325 - 327 Deansgate – Manchester

S73 Minor Material Amendment | December 2023

10446-A-B5D8-RP-DAS-003

Current Planning Permission

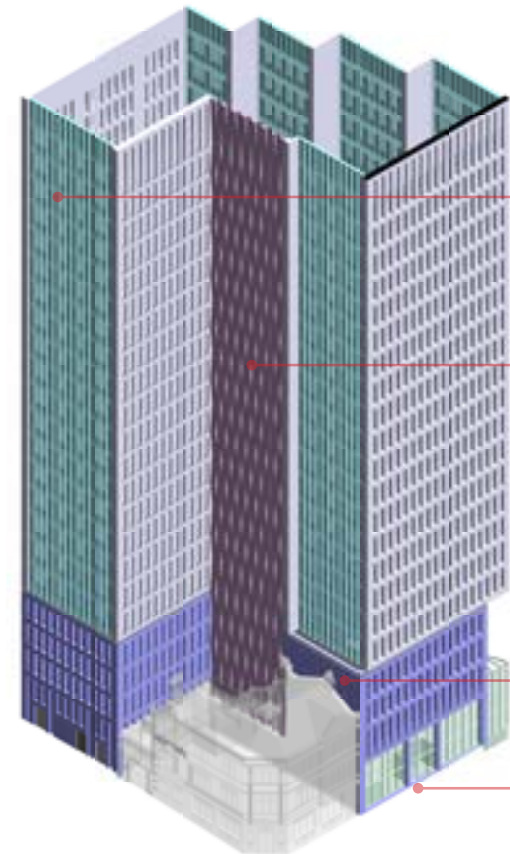
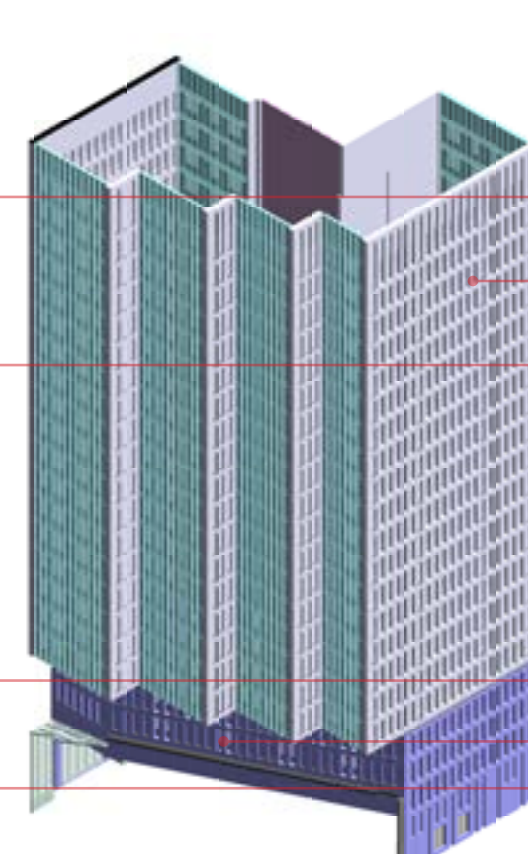
Treatments two and three currently utilises precast concrete panels to generate the gridded and patterned façades described above. This document sets out proposals to replace the precast concrete with alternative materials that will enhance the visual appearance of the development.

A façade design using precast concrete panels was reviewed in more detail during the developed design of the proposals. However, the site is heavily constrained, with a party wall condition at the adjacent Deansgate Pub; facades which cantilever over the TfGM viaduct to the south and are immediately adjacent to the exclusion zone for construction set out from the Metrolink infrastructure; and on the West elevation the building abuts Deansgate a major North to South vehicular and pedestrian route through the city centre. These boundary conditions, and in particular the constraints building next to the Metrolink, mean that large scale precast façade panels cannot physically be craned into the site without significant risk to adjacent assets. The revised proposals ensure that mast climber installation is used with no risk of façade elements impinging adjacent exclusion zones.

As an alternative solution, to work within the materiality of the planning permission, the design team have explored use of glass reinforced concrete panels (GRC), which could be installed in smaller pieces and by hand via mast climber and would be more forgiving in terms of weight and the fixing constraints noted above. However, there were concerns over the perceived quality of the GRC product when compared to a traditional precast concrete solution, and it was considered that alternative rainscreen products could offer a higher quality façade solution whilst working alongside the building frame design and within the proximity constraints associated with the site.

TfGM Exclusion Zone - Plan

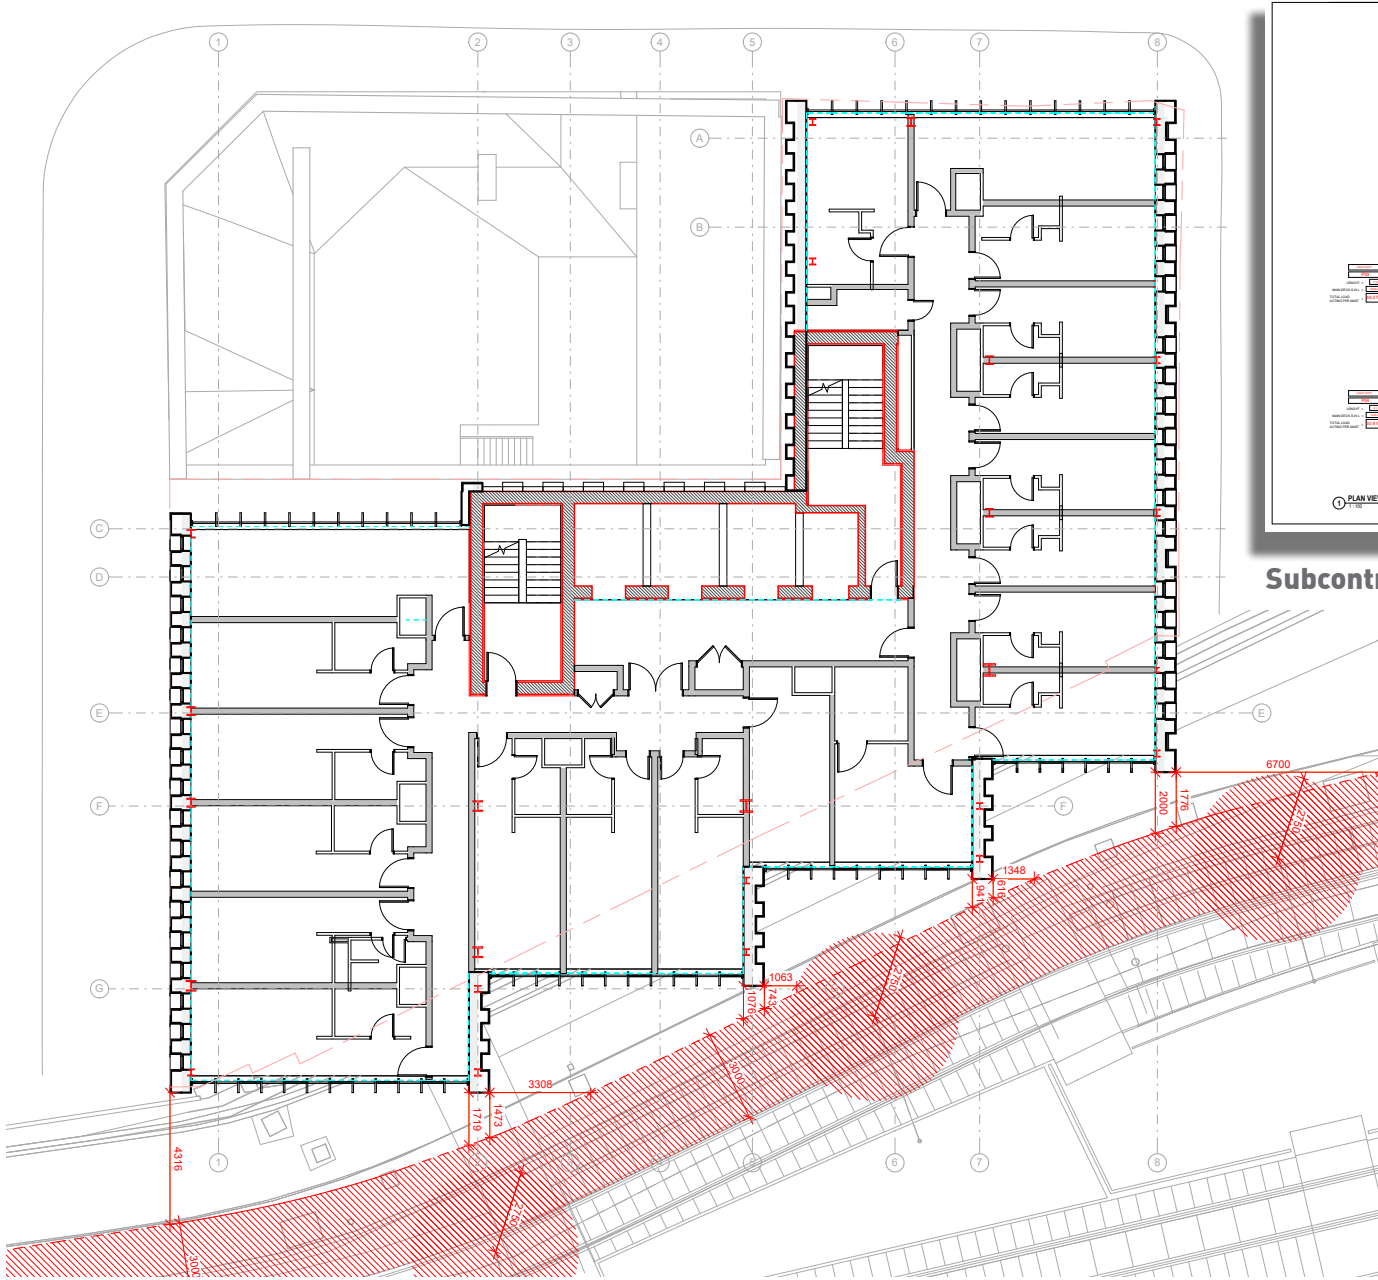
1. Precast installation over pub roof
2. Precast installation adjacent to viaduct and under overhanging floor plates
3. Limited precast at ground level to front of house (Deansgate) elevation - majority of precast to back of house locations.

3D Bay Study - Terracotta / Brick

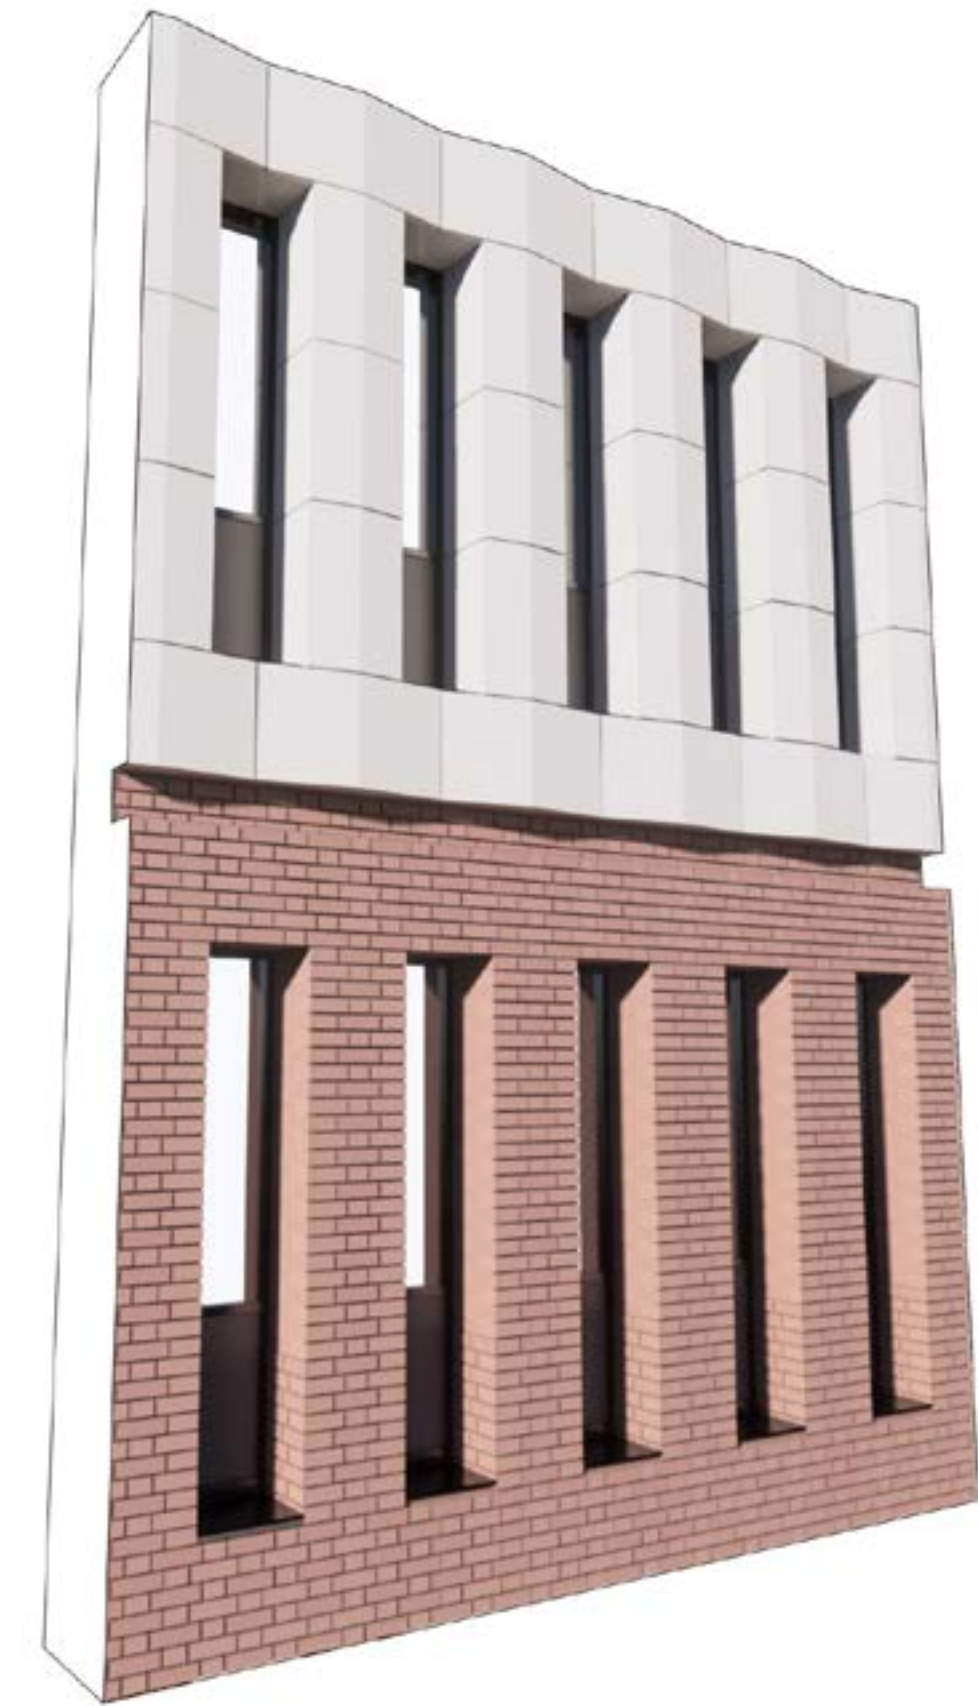
The proposed external material amendments adopt the principles outlined above, looking to further enhance the shift between forms, and to better connect the podium form into the streetscape by using a brick cladding in lieu of red precast from ground to Level three. The brick will be a mortared rainscreen system, utilising brick slips on a carrier rail system, and will avoid any use of ‘cut and stuck’ slips, with pistol brick corners formed to all window reveals and building corners. Visually the system will match exactly a traditional brick building, but with the advantage that the system is a rainscreen hung from the internal backing wall rather than being a structural brick façade built up from ground level.

The proposed brick slip, sourced from a UK supplier, will match the viaduct and Deansgate pub in ‘Manchester red’. Careful selection through sampling and formal sign off with the city will ensure the chosen brick has a strong contextual relationship to the surroundings.

To contrast the texture and colour of a red brick on the lower floors, the amended proposals seek to utilise a white glazed terracotta tile to the upper facades. The ability of this material to provide some reflection offers an opportunity to get a better sense of movement to the façade on the upper floors, and a slight inflection is proposed in the elevation grid to enhance this quality in the amended choice of material.

Original Planning - Curtain Wall Facade Proposal

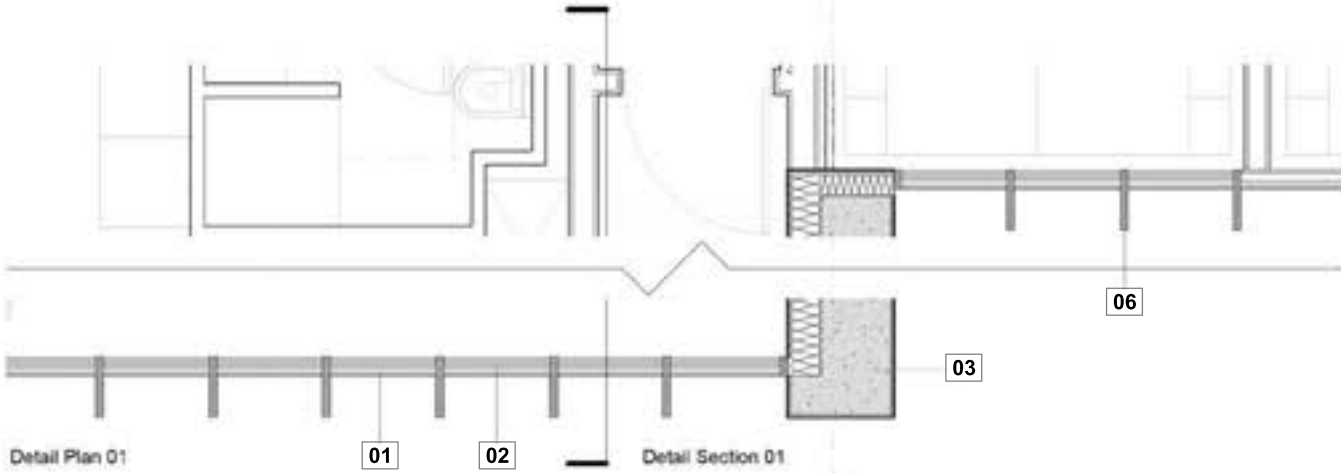
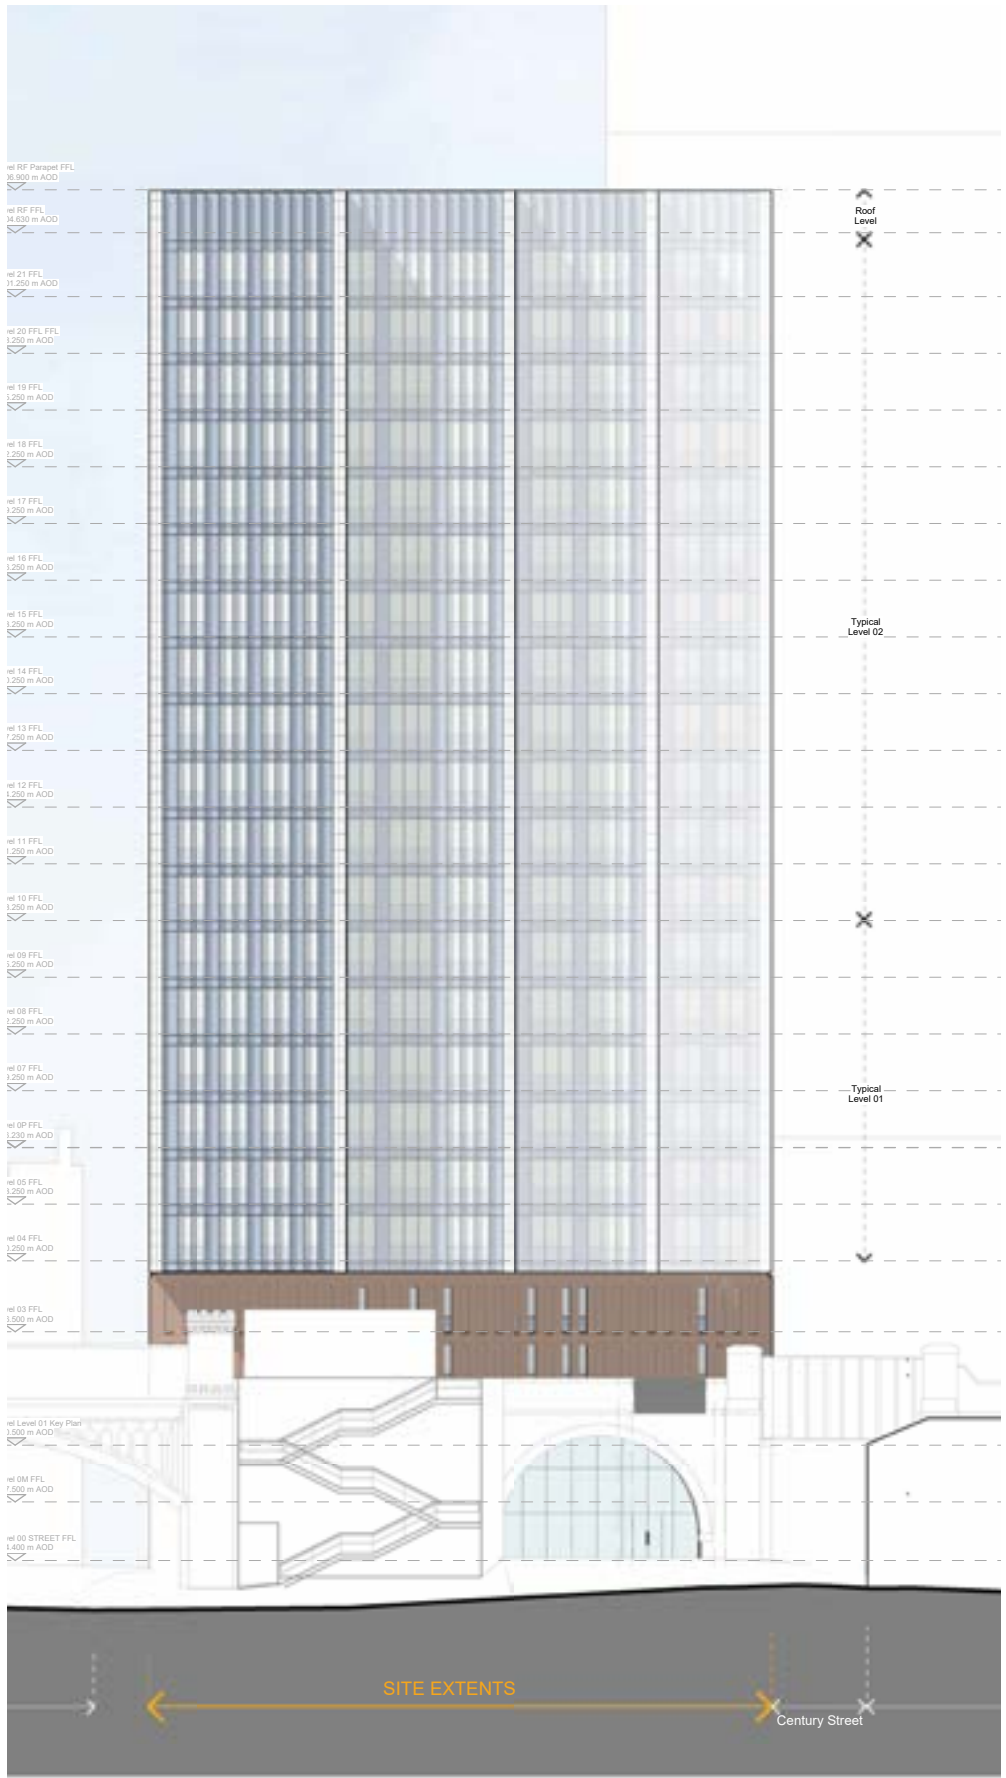
Our amended proposal suggests omitting the horizontal aluminium louvres at floor levels and replacing with an opaque glazed panel. We believe this amendment also offers a visual improvement to these façade areas, minimising the horizontal bands in the current scheme so the verticality and slenderness of these façades, still animated by the aluminium fins, will be accentuated.

West (Deansgate) Elevation - Proposed Amendments

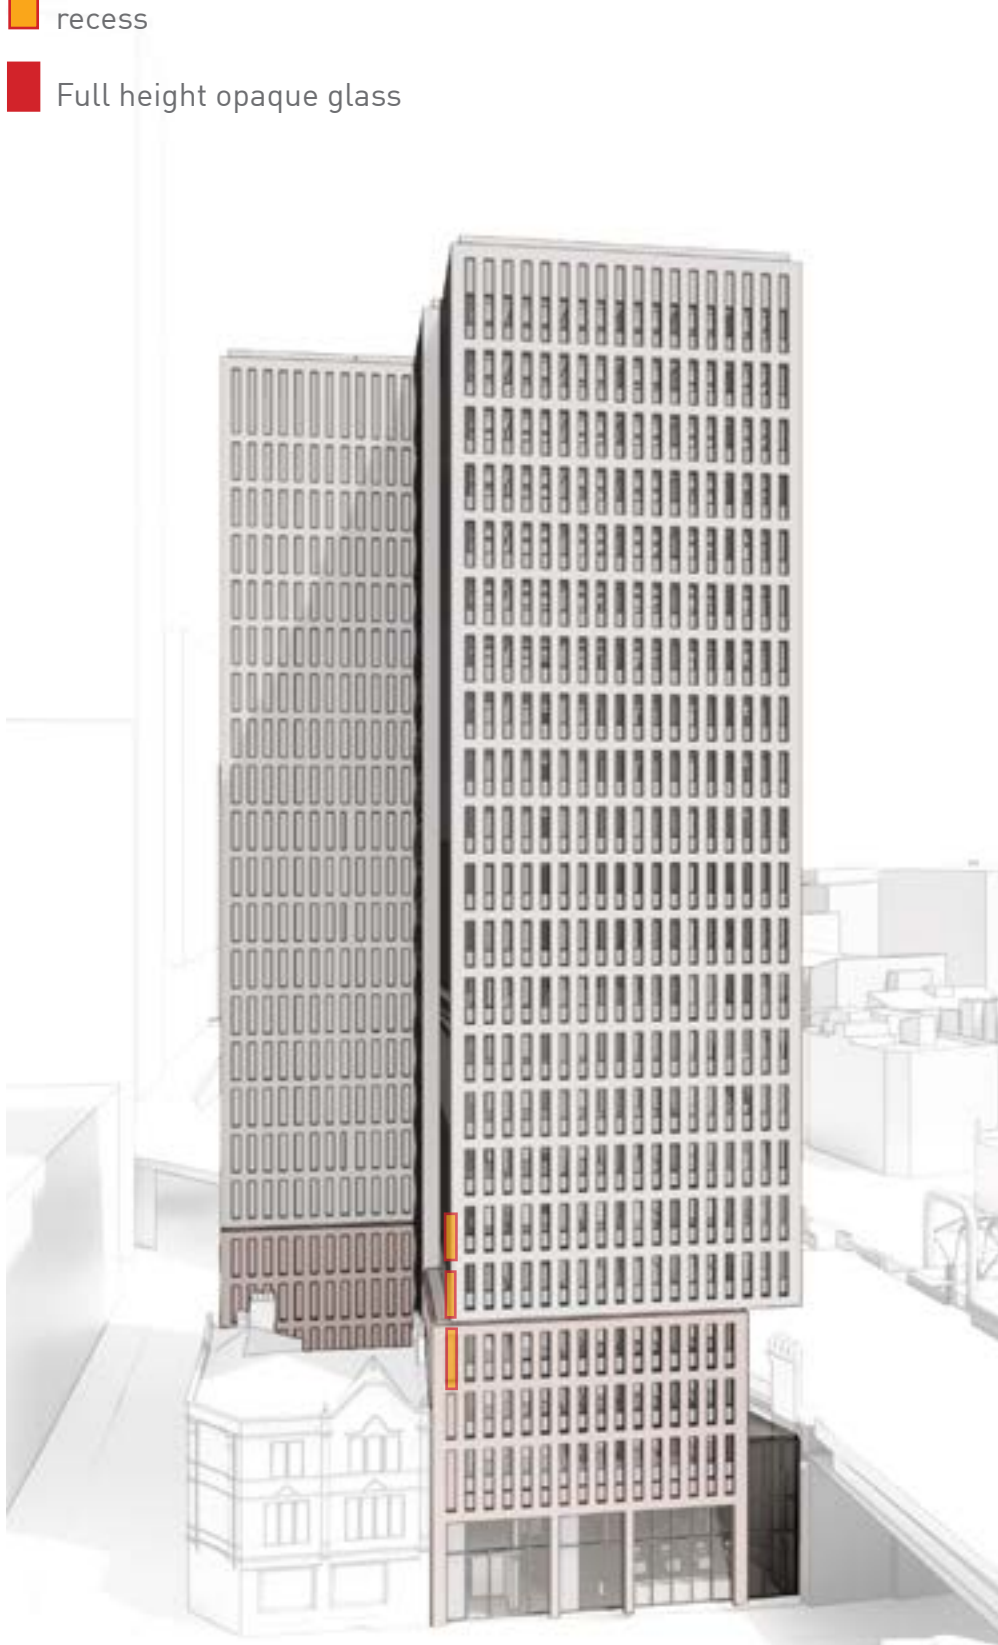
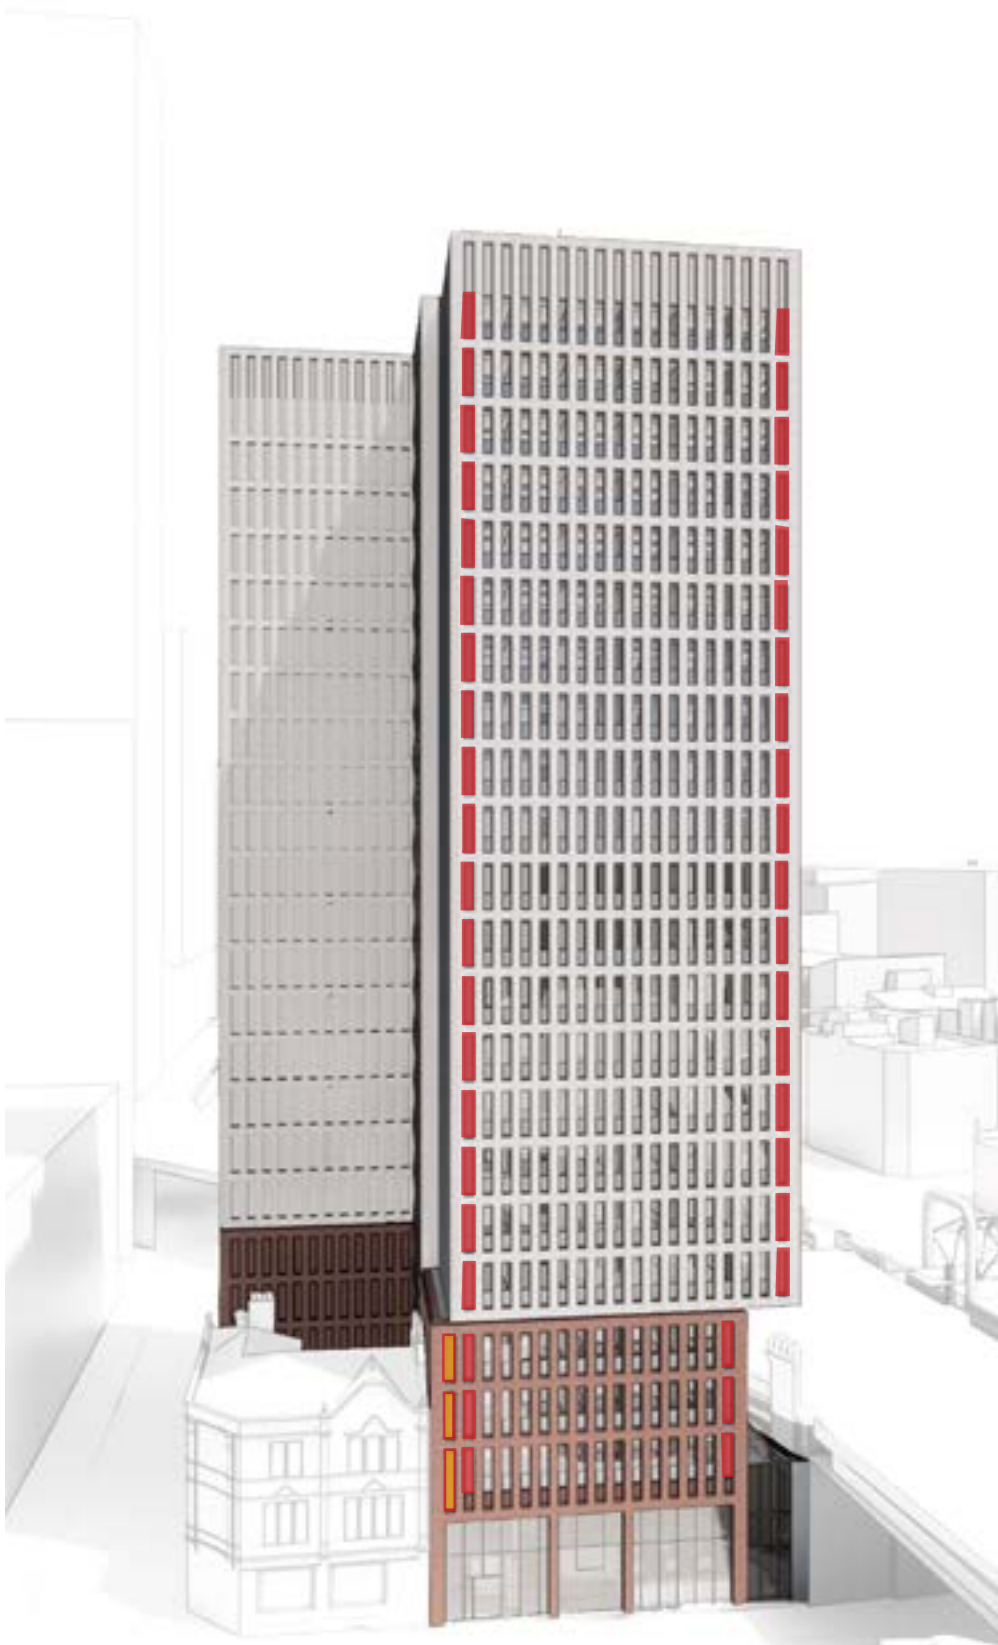
On the West elevation, the updated proposals retain the language of symmetry and verticality set up in the existing planning permission. Vertical bands of opaque glass are located to the first and last windows on the floor plate, framing the remaining facade which is composed of vision glass.

- Blank terracotta / brick (formerly concrete) recess
- Full height opaque glass
